## ORIGINATION FORM

### Proposed Revisions to a Standard Plans Index (Please provide all information — Incomplete forms will be returned)

Index Number: 521-660

Index Title: Light Pole Pedestal - Bridge

CONVENTIONAL REINFORCING STEEL BENDING DIAGRAM

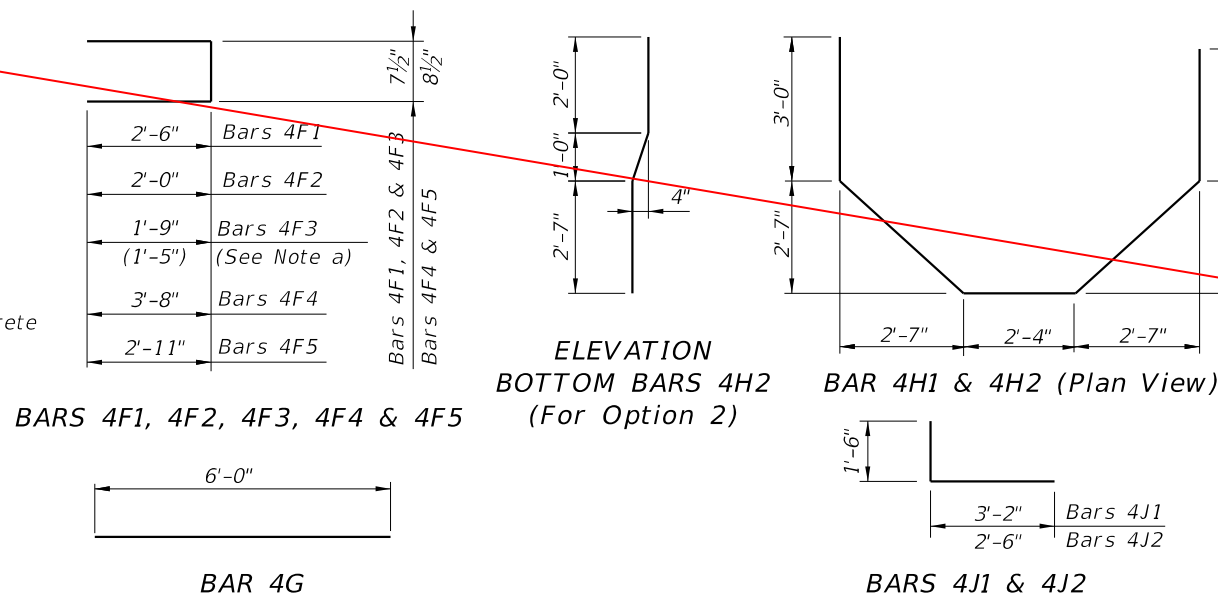
Reworked bar list to fit in new option

- e. All bar dimensions in the bending diagrams are out to out.
- f. 4H2 bar offsets out of plane for option 3. See elevation dimensioning shown.

MARK	SIZE	NO. REQD.	LENGTH	NOTES
F1	4	16	5'-8"	c
F2	4	4	4'-8"	c
F3	4	4	4'-2" (3'-6")	a, c
F4	4	8 (6) [4 for Option 2]	8'-6"	b, c
F5	4	4	6'-6"	c
F6	4	4	3'-0"	-
F7	4	4	3'-5"	-
F8	4	12	4'-1"	-
G	4	8 [5 for Option 2] [24 for Option 2]	6'-0"	-
H1	4	2	15'-8"	-
H2	4	2	13'-10"	-
J1	4	8	4'-8"	d
J2	4	12	4'-0"	d

DETAIL "A"

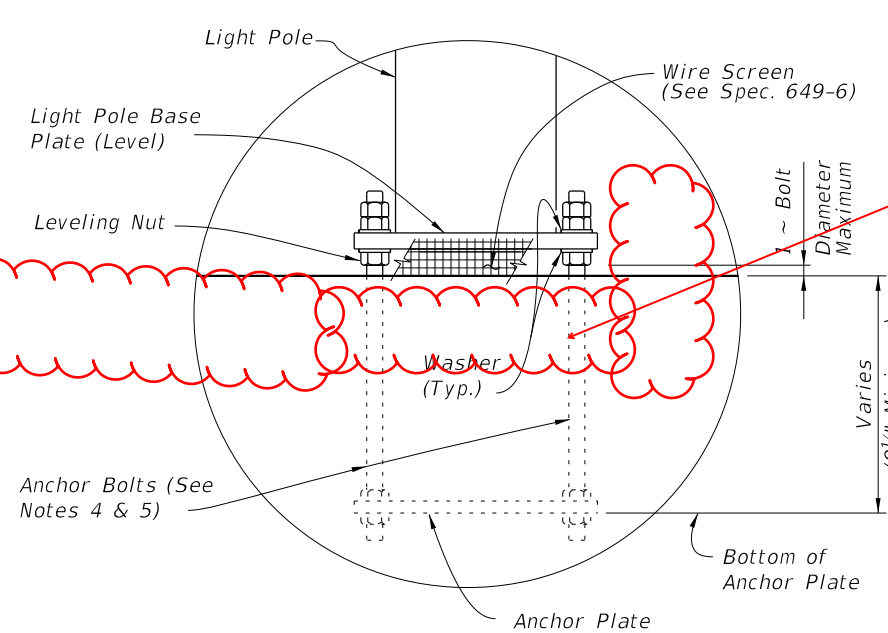
Added anchor nut for bottom of pedestal anchor breakout

OPTION 3 - PLAN VIEW WITH GAP BETWEEN BARRIER AND PEDESTAL TO ALLOW SLIP FORMING

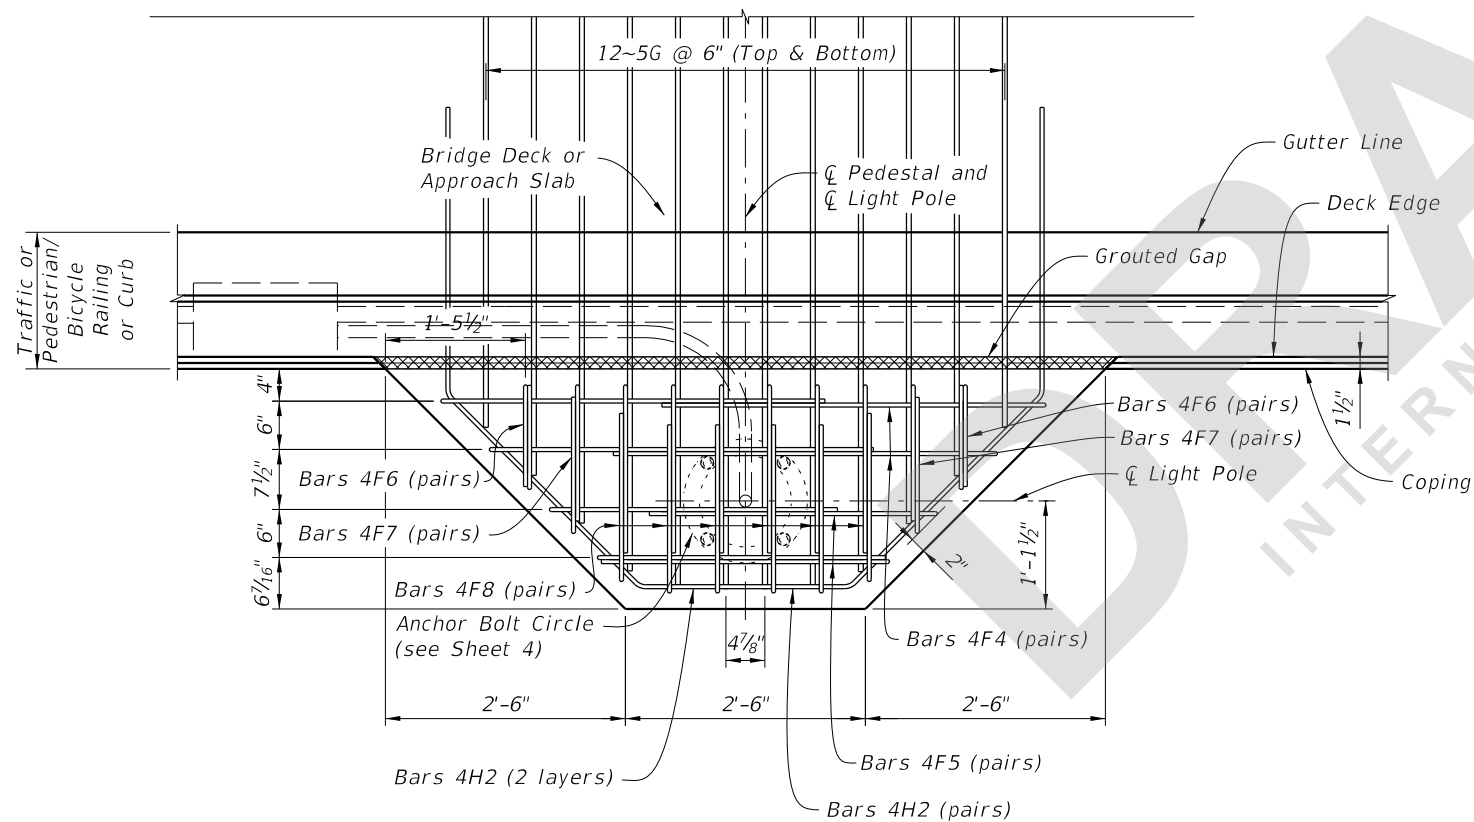
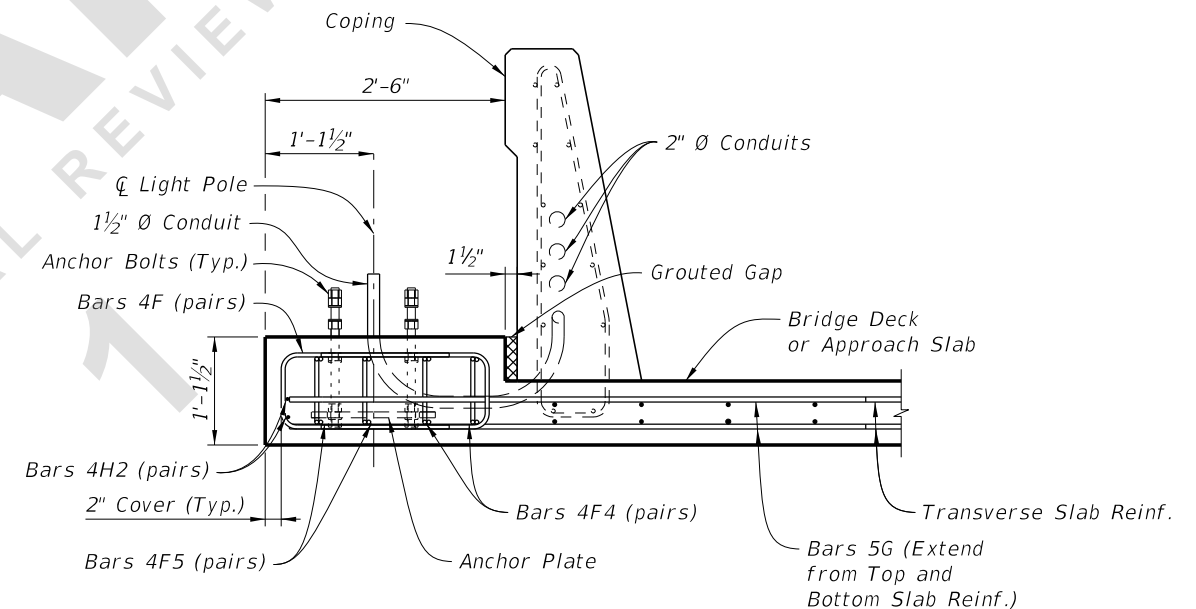
An option was included to allow for slip forming of the traffic barrier at the pedestal location. A gap was included between the barrier and pedestal to facilitate this.

Contractor request in order to save time and materials required to form barrier separately at light pedestal locations.

OPTION 3 - TYPICAL SECTION AT LIGHT POLE PEDESTAL WITH GAP BETWEEN BARRIER AND PEDESTAL TO ALLOW SLIP FORMING
